SEWAGE DISPOSAL SYSTEM

REPAIR

HOWARD COUNTY

SUBDIVISION _____ ROAD ⁸⁶⁶³8662 Guilford Rd. LOT _____

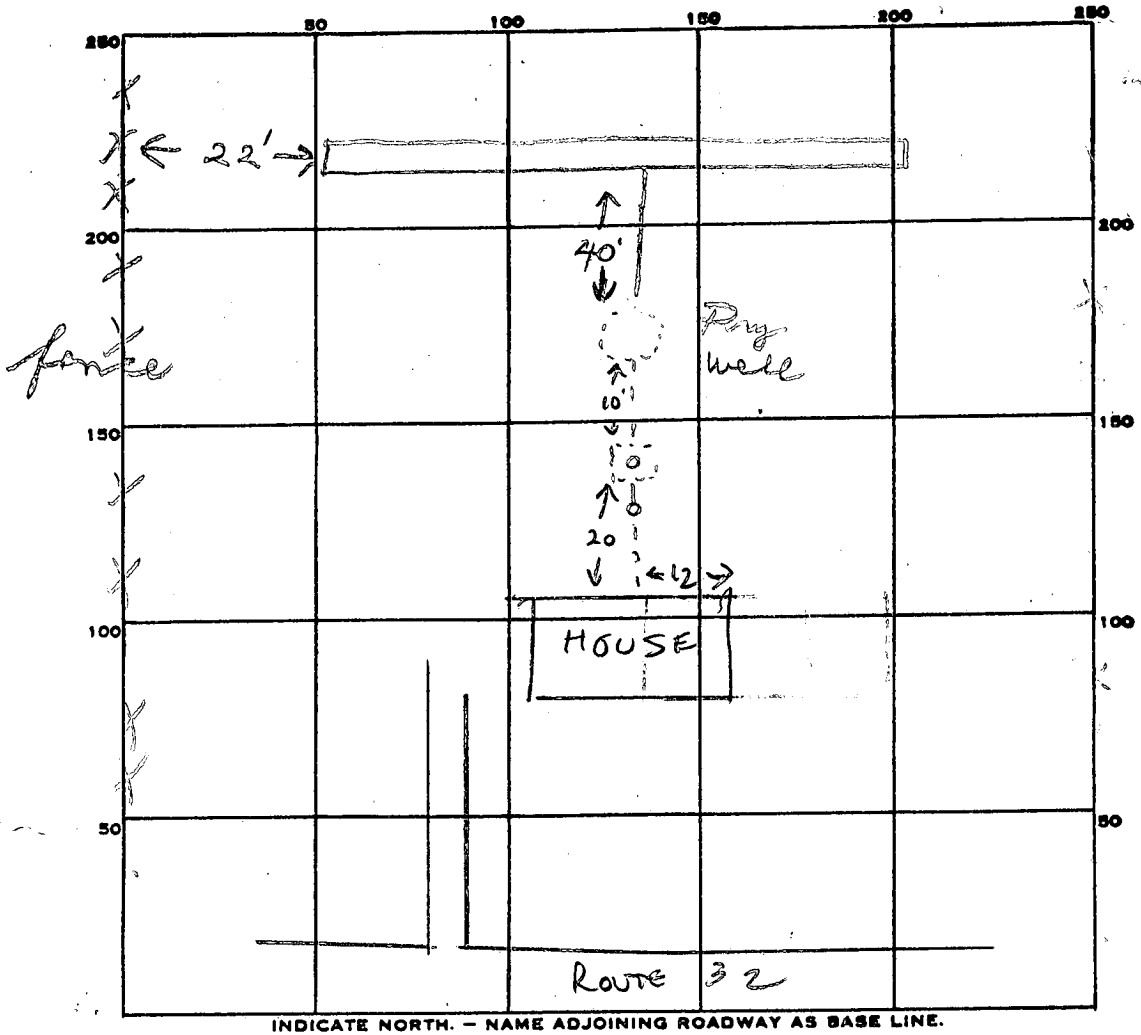
REPAIR - CALL FOR INSPECTION WHEN GROUND IS OPENED UP SO SANITARIAN CAN

RECOMMEND REPAIR.

- REQUIRE 75' TRENCH. EFFECTIVE 4'-9"

LOCATE 30' DOWNHILL FROM DRYWELL.

REMARKS 3/30/83 - OK to cover all work of
